PLAN REVIEW CENTER REPORT

June 4, 2008

Planning Review

Premier Medical – Mobile MRI Unit

SHEET
Storm Water Management As-Built Plan

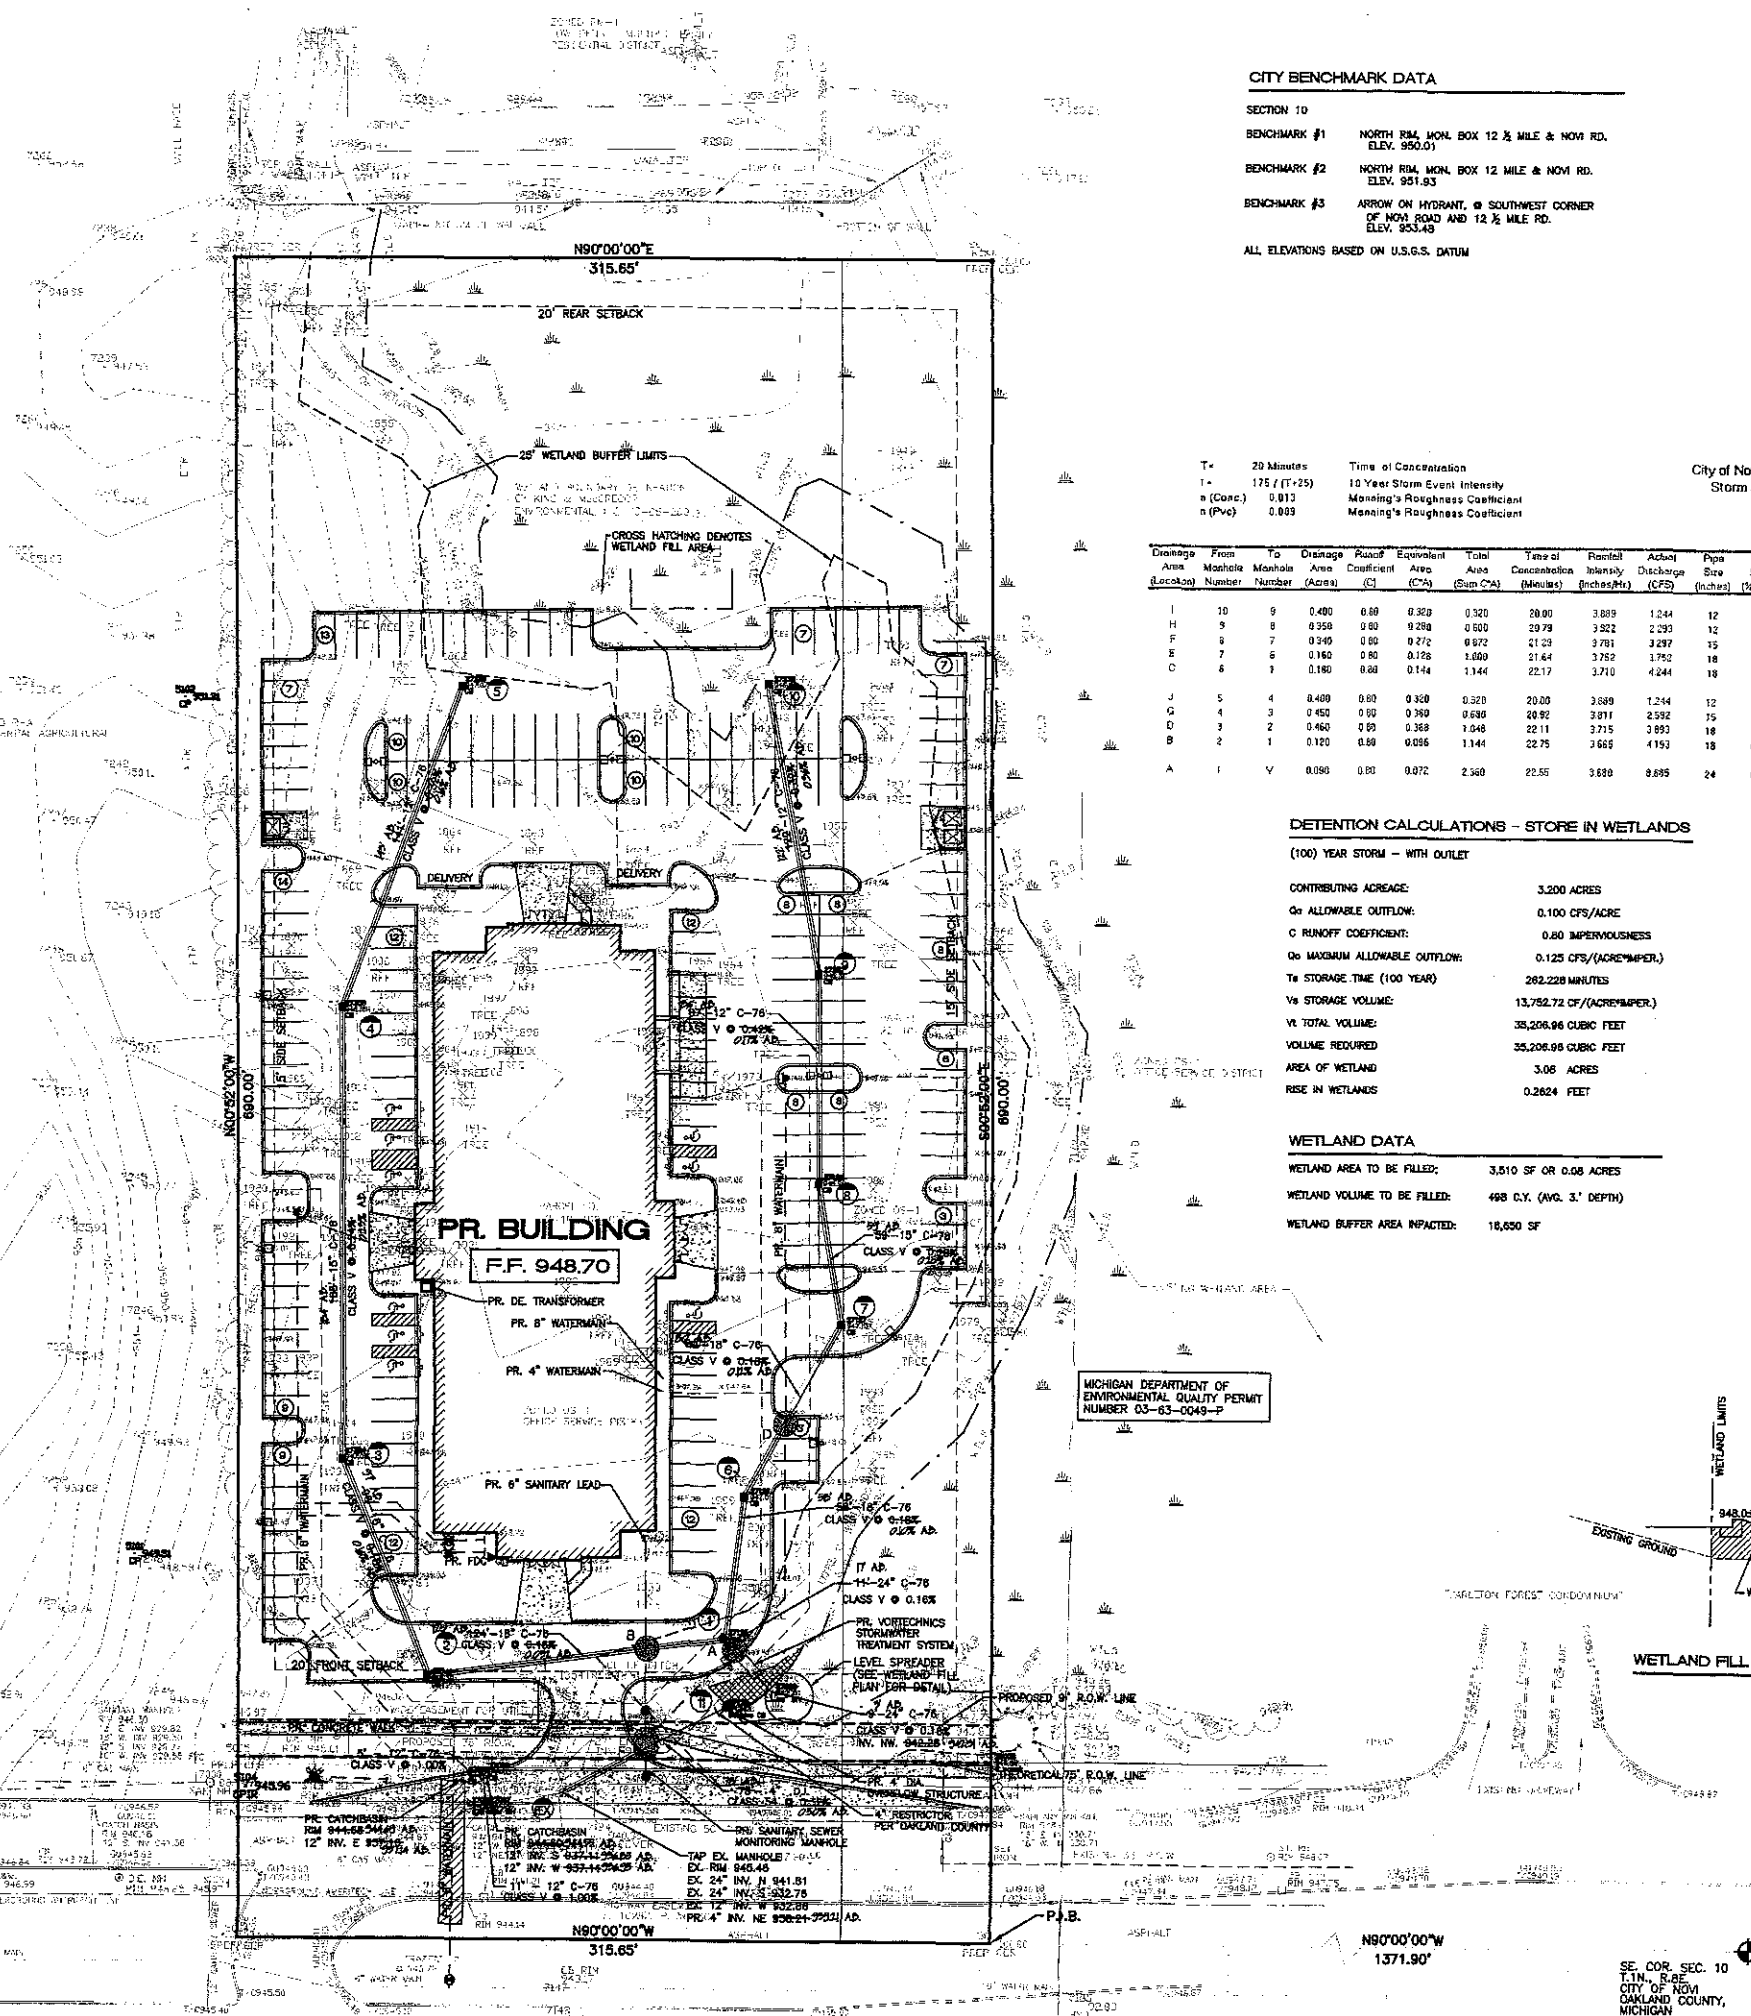
1. Parking Spaces: The existing medical office building is required to have 203 parking spaces. The parking lot currently contains 206 spaces. The proposed mobile MRI unit will occupy six spaces, resulting in a loss of six spaces and bringing the parking count down to 200 spaces, three spaces below the requirement. **The applicant will need to appear before the Zoning Board of Appeals for a variance for lack of adequate parking on site.**

The applicant should appeal to the Zoning Board of Appeals for a variance for the lack of adequate on site parking as a result of the location of the mobile MRI unit.
